# Ozone Reactivity Measurement of Biogenic Volatile Organic Compound Emissions

## Response to Anonymous Referee #1

## Response to Anonymous Referee #2

**Figure R1.** Response of the fast NO monitor placed after the reactor after injection of NO in the reactor flow for 4 and 6  $l\ min^{-1}$  (in blue and orange, respectively).

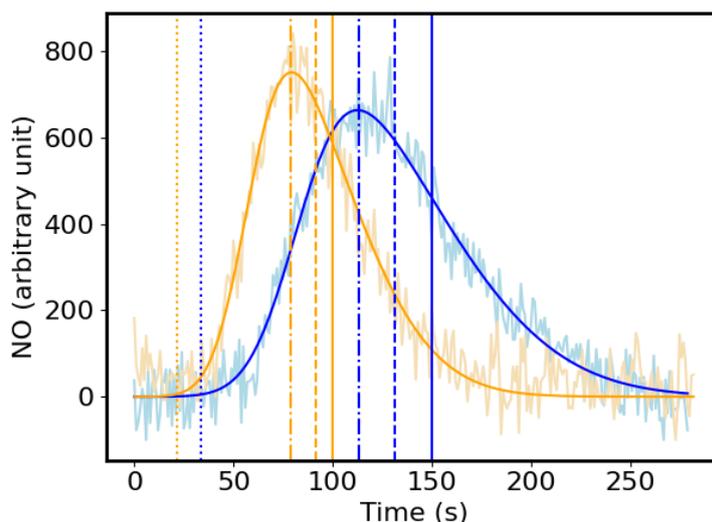
Section 3.4. What is the purpose of changing the plumbing of the reactor? It only shows that in the changed configuration the residence time is a little longer. In any case, why was the residence time determined using a 4 slpm flow, when the actual reactor flow is 4.4 (or 5, see comment above)? In the end, the authors settle on a 120 seconds residence time, which suggests that the theoretical value calculated at 5 slpm was used. But this does not make sense as the experiment described in this section indicate that the theoretical value is ~30 seconds too long compared to the actual value. In addition a residence time of 167 seconds is mentioned on page 22 and a value of 150 seconds is used in Supplement B. The residence time is a key parameter of the system, and therefore it should be clear what it is. The work in this section should be better explained and the reasoning behind the choice of the final value used for all subsequent analysis should be clearly explained.

***Changing the flow through the reactor in the reverse direction was done to assess (see line 706) the effect of the dip tube on the flow characteristics of the system. The test confirmed that introducing air through the dip tube results in a narrower distribution for the residence time (lines 716-717), which is advantageous for the purpose of the experiment.***

***A set of tests were performed to characterize and improve the experiment. Those at times required a different plumbing as the default configuration, which affected the flow through the reactor. However, the experimental determination of the residence time as described in section 3.4 was performed only with one system configuration with flows of 4 and 6 l min<sup>-1</sup> through the reactor, with 4 l min<sup>-1</sup> used in the default configuration as clarified above. There are various ways to define the residence time, as also discussed by Sommariva et al. (2020), and as depicted in Fig. R1 below. It can be (1) the time when the signal starts to increase, (2) the mode of the distribution, i.e. the most frequent residence time, (3) the mean of the distribution, and (4) the theoretical residence time based on reactor volume and flow rate calculation. In the original manuscript, we used the definitions (2) and (4), leading to the inconsistencies pointed out by the referee. In the revised manuscript, we explain that we use the mean of the residence time distribution (3) for ozone reactivity calculations. These times are 132 s and 79 s for the 4 and 6 l min<sup>-1</sup> flows, respectively. This corresponds to fractions of 0.88 and 0.91 of the theoretical residence time. When the flow through the reactor deviates from 4 or 6 l min<sup>-1</sup> at which we have experimental data, we applied a factor 0.9 to the theoretical value in order to utilize a residence time that is more in line with the experimentally determined value.***
